TECHNICAL BULLETIN
Bell Helicopter **TEXTRON**

No. 222U-03-97

MODEL AFFECTED: 222U

SUBJECT: TAIL ROTOR GUARD SUPPORT, IMPROVEMENT OF

Figure 1 Tail Rotor Guard Installation (Before Modification)

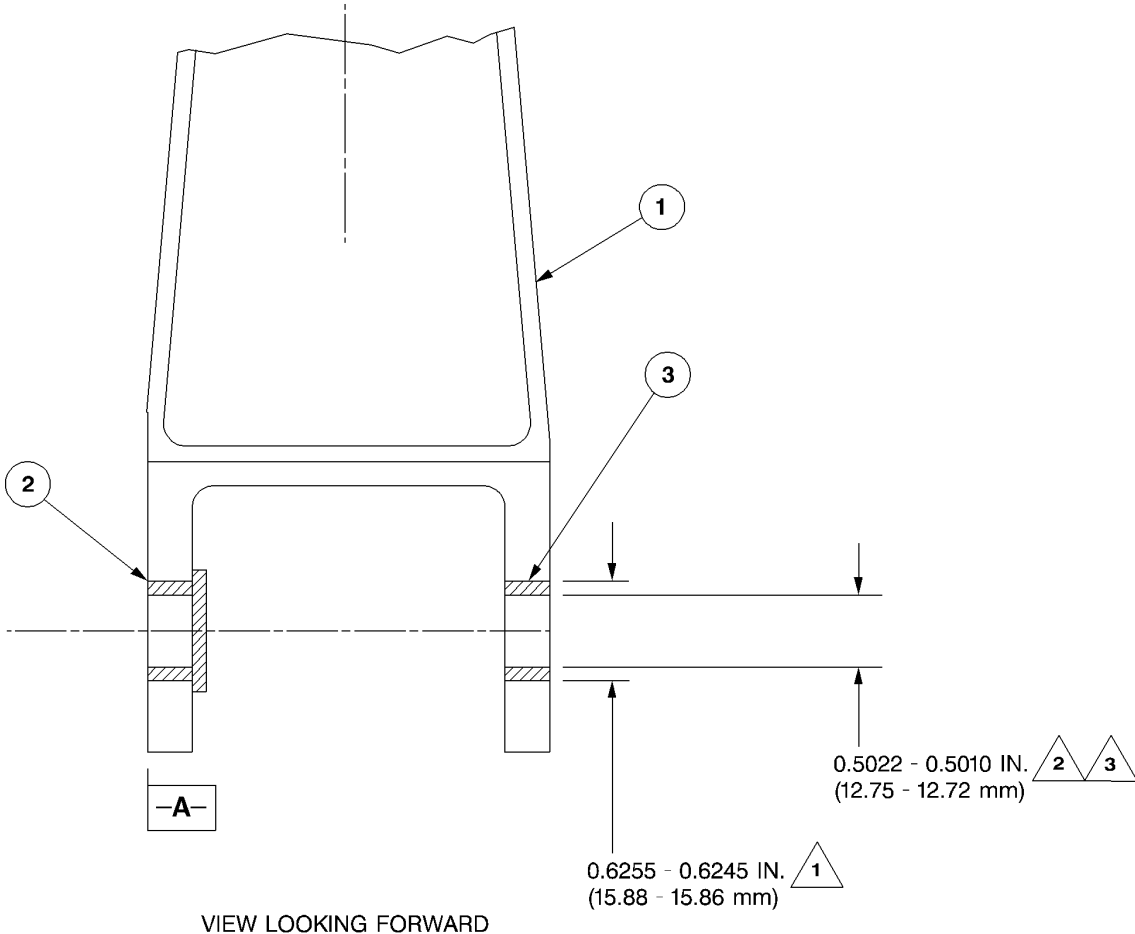
There are two supports that are made from aluminum castings that retain the tail rotor guard installation. The forward support 222-035-168-101 is attached to the tailboom and aft support 222-035-231-105 is part of the lower vertical fin. Reports indicate that hole elongation occurs in the forward and aft supports of the tail rotor guard. This bulletin introduces a bushing in the forward and aft supports to maintain the correct tolerance for mounting hardware.

1. Remove tail rotor guard assembly 222-035-350-105. Retain hardware for re-use. Replace any damaged hardware. Refer to BHT-222U-MM-5 for instructions. Refer to Figure 1 for location.

Figure 2 Forward Support Modification - (sheet 1 of 2)

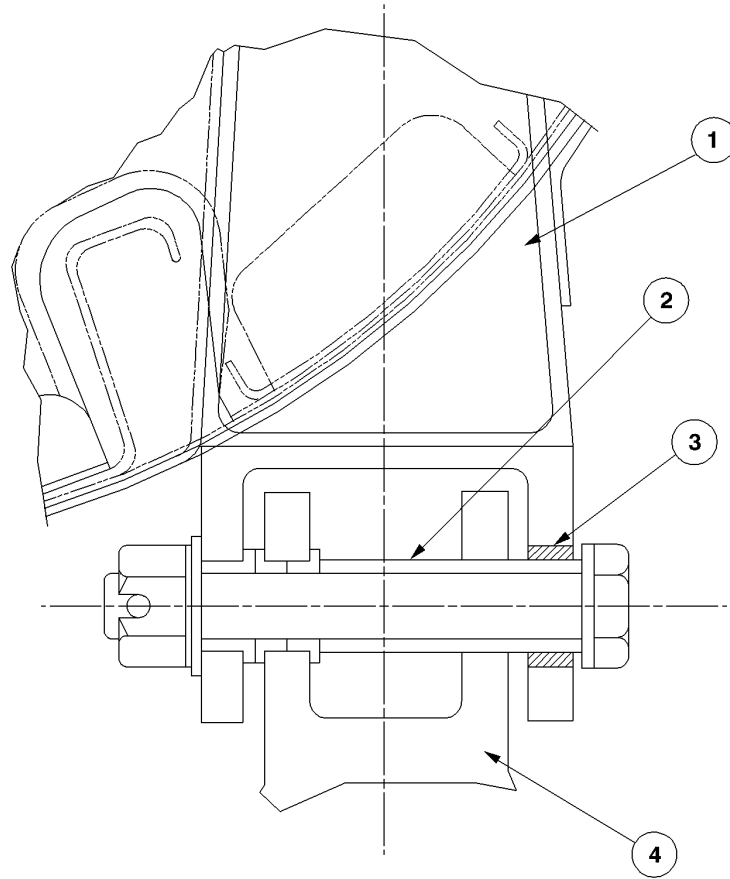
2. Inspect exposed area of fitting for corrosion and damage, visually inspect area for cracks using a 10X magnifying glass. If additional damage is found then contact Bell Helicopter Product Support.
3. Drill and ream hole in support 222-035-168-101. Reamed hole must be perpendicular to surface "A" to within 0.005 inch (0.13mm). Refer to figure 2, sheet 1 for dimensions. Do not modify existing bushing install.
4. Debur edges of hole and clean area.

5. Apply primer TT-P-1757 to new bushing and reamed hole. Thermal fit new bushing 21-010A15-8 into support while primer is still wet. Ensure bushing is flush with both sides of lug. Refer to BHT-ALL-SPM, section 8-10 for bushing installation instructions. Allow primer to cure.
6. Ream inside diameter of bushing in line with opposite bushing. Refer to figure 2, sheet 1 for dimensions.
7. Prime all bare metal areas using MIL-P-23377. Re-finish as required.

- 1 Hole in casting must be perpendicular to surface -A- to within 0.005 inch (0.13 mm).
- 2 Install bushing 21-010A15-8 with wet zinc chromate primer TT-P-1757.
- 3 Ream I.D. of bushing inline with opposite existing bushing.

Figure 2 Forward Support – After Modification - (sheet 2 of 2)

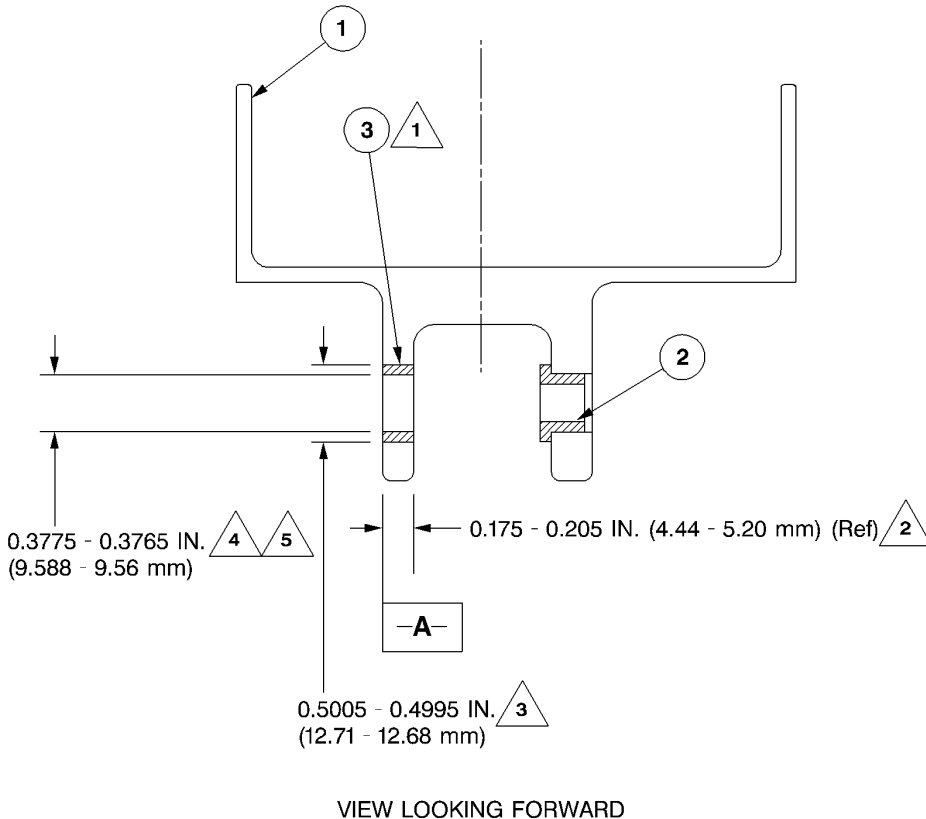
6. Apply primer TT-P-1757 to new bushing and reamed hole. Thermal fit new bushing 21-008A11-7 into support while primer is still wet. Ensure bushing is flush with both sides of lug. Refer to BHT-ALL-SPM, section 8-10 for bushing installation instructions. Allow primer to cure.
7. Ream inside diameter of bushing in line with opposite bushing. Refer to figure 3, sheet 1 for dimensions.
8. Re-assemble tail rotor guard installation as indicated in BHT-222U-MM-5 and figure 2 sheet 2, figure 3 sheet 3 of this bulletin.

Figure 3 Aft Support Modification - (sheet 1 of 3)

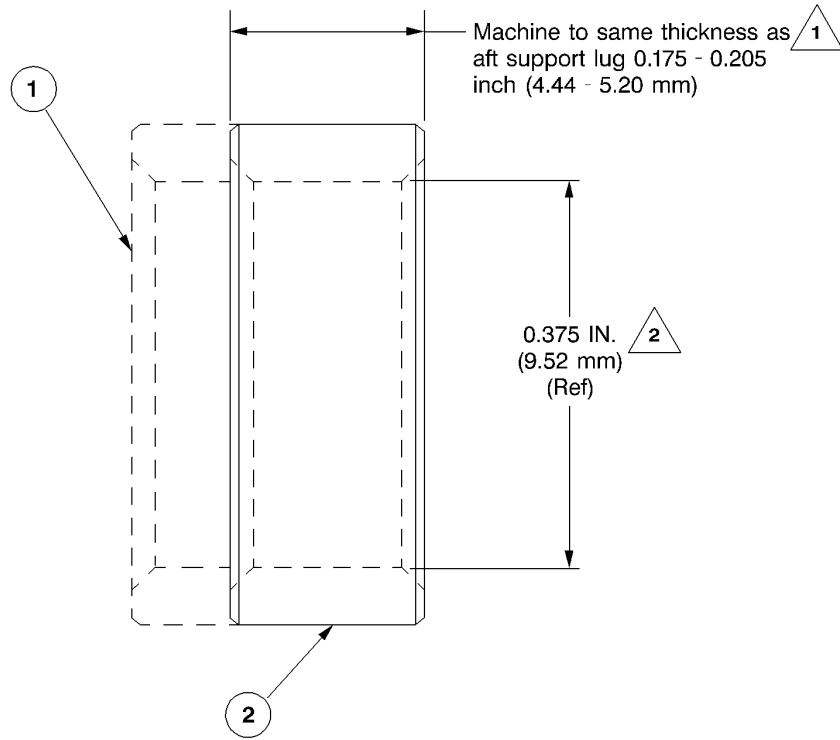
1. Remove tail rotor guard assembly 222-035-350-105, if installed. Retain hardware for re-use. Replace any damaged hardware. Refer to figure 1 for location.
2. Inspect exposed area of fitting for corrosion and damage, visually inspect area for cracks using a 10X magnifying glass. If additional damage is found then contact Bell Helicopter Product Support.
3. Drill and ream hole in support 222-035-231-105. Reamed hole must be perpendicular to surface "A" to within 0.005 inch (0.13mm). Refer to figure 3, sheet 1 for dimensions. Do not modify existing bushing installation.
4. Deburr edges of hole and clean area.

- 1 Machine new bushing 21-008A11-7 to existing lug thickness.
- 2 The lug on the aft casting may vary in thickness from 0.175 inch (4.44 mm) - 0.205 inch (5.20 mm).
- 3 Hole in casting must be perpendicular to surface -A- to within 0.005 inch (0.13 mm).
- 4 Install bushing 21-008A11-7FM with wet zinc chromate primer TT-P-1757.
- 5 Ream I.D. of bushing 21-008A11-7FM inline with opposite existing bushing.

Figure 3 Aft Support Bushing (sheet 2 of 3)

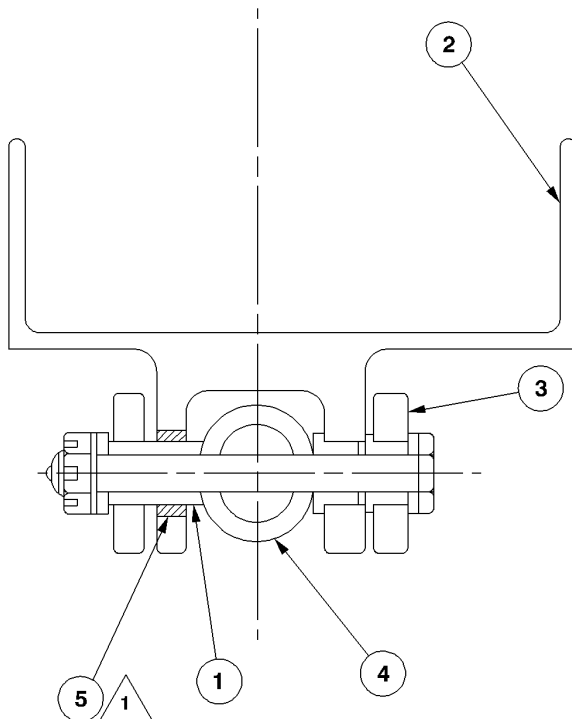
5. Locally machine new bushing 21-008A11-7 to length and chamfered as shown in figure 3, sheet 2.

- 1 Chamfer outer diameters to 0.005 inch (0.13 mm) - 0.015 inch (0.38 mm) x 40° - 50°, typical.
- 2 Chamfer inner diameters to 0.025 inch (0.63 mm) - 0.035 inch (0.88 mm) x 40° - 50°, typical.
